Flytec 6020 / Bräuniger IQ Competino+

Firmware Release Notes

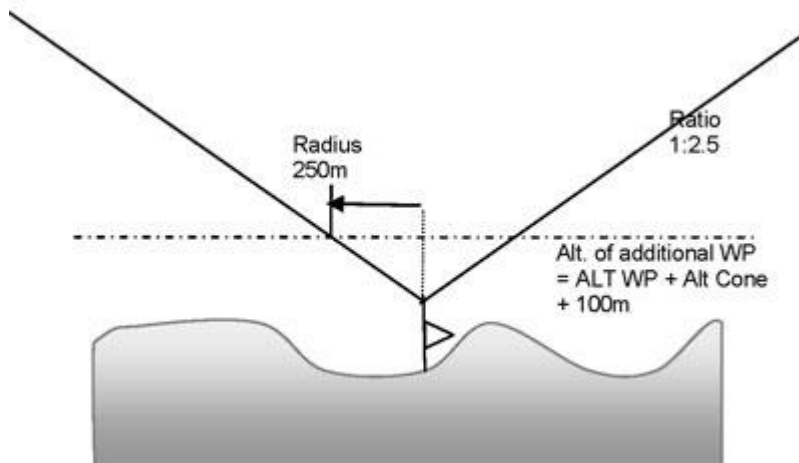
- Support of various GPS modules
- Bugfix in near Thermal, Sinktone setting in fpm
- quick return from the Mode menu
- SW Version Character in IGC-File
- Acoustics suppressed during turning off. This solves the problem with the random acoustic after turning off.
- Log file on SD card
- Support Conical CESS
- This test version includes the ability to define the new conical end of speed section (CESS). In this version it is possible to set the second to last waypoint in the Competition Route as a CESS cone. The cone is defined with the default slope ratio of 1:2.5 and the radius of the truncated tip at the elevation plane of the waypoint (based on the waypoint altitude as entered in the waypoint list). As shown below:

- It has come to our attention that the PWC failed to inform us that it is allowable to define a CESS where the tip of the cone is floating above the ground. For this reason, please follow the procedure below to enter such a CESS. Once the CESS concept is fully defined and codified, Flytec will of course, create an easier method to define a "floating CESS" in the instrument.

- At the moment, the best way to define a floating CESS in the 6030:
 - 1- duplicate the waypoint to be used for the CESS but with the altitude set to the altitude of the CESS tip plus 100m

- 2- set the CESS radius in the Competition Route to 250m (which equals to the cone ratio of 1:2.5). If a different slope is used then the radius will need to be adjusted appropriately (i.e., $100 * \text{slope}$)

- As an example from the first practice task: The cone was defined with the tip at 50m AGL or 231m MSL and ratio 1:2.5. In this case you must make a new waypoint (with the same coordinates) with altitude set at $(231\text{m} + 100\text{m} = 331\text{m})$. Then set the radius to 250m and the ratio to 2.5 when setting the parameters for the CESS in the Competition Route.
